8 SUB-000390-2018

THEODORE INDUSTRIAL PARK SUBDIVISION

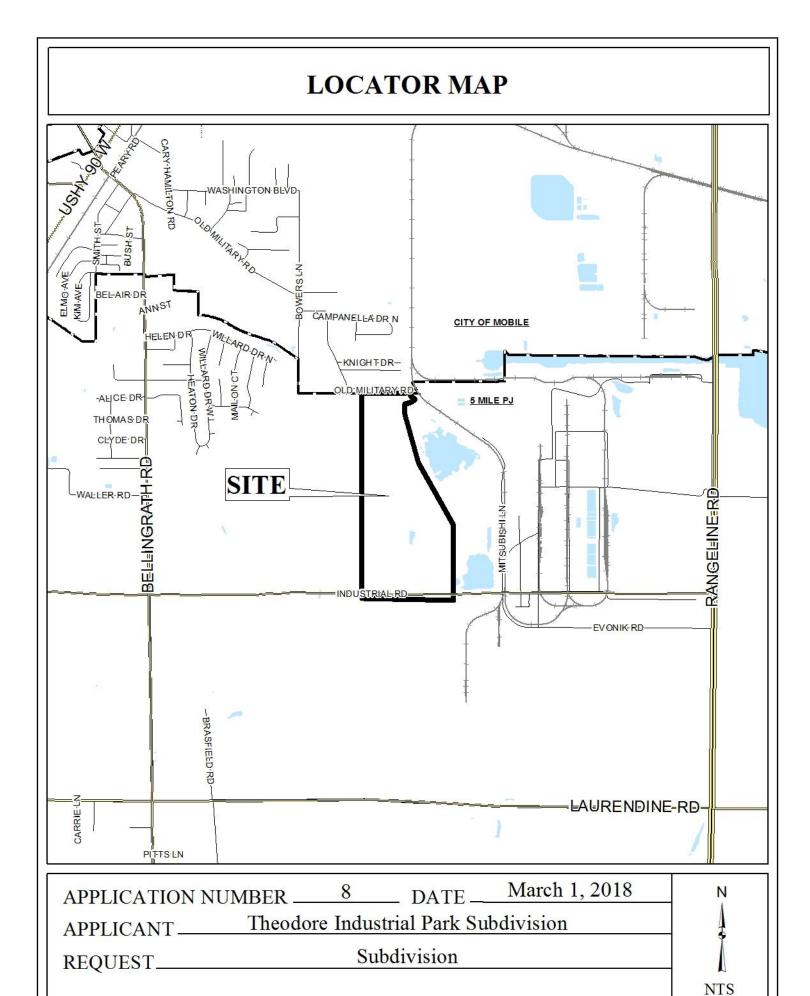
The 25-foot minimum building setback line, required in Section V.D.9., is not illustrated on the plat. Staff has determined that because the site is an industrial site and there are various railroad spur easements located throughout the property, the 25' minimum building setback requirements will not be required where the railroad easements are depicted on the plat.

The proposed lots meet the minimum size requirements of the Subdivision Regulations; however, the lots are labeled with their sizes in acres only. Therefore, the plat should be revised

to label each lot with its size in both square feet and acres, or a table should be furnished on the Final Plat providing the same information.

There are several drainage, utility, and access easements located on the site. A note should be placed on the Final Plat stating no structures shall be constructed or placed within any easements.

- 1. revision of the plat to depict the 25' minimum building setback line except from street rights-of-way where the railroad easements are illustrated on the plat;

- 2. revision of the plat to label each lot with its size in both square feet and acres, or the furnishing of a table on the Final Plat providing the same information;

- 3. placement of a note on the Final Plat stating that no structures shall be constructed or placed within any easements;
- 4. placement of a note on the Final Plat stating that development will be designed to comply with the stormwater detention and drainage facilities of the City of Mobile stormwater and flood control ordinances, and requiring submission of certification from a licensed engineer certifying that the design complies with the stormwater detention and drainage facilities of the City of Mobile stormwater and flood control ordinances prior to the issuance of any permits. Certification to be submitted to the Planning and Zoning Department and County Engineering;
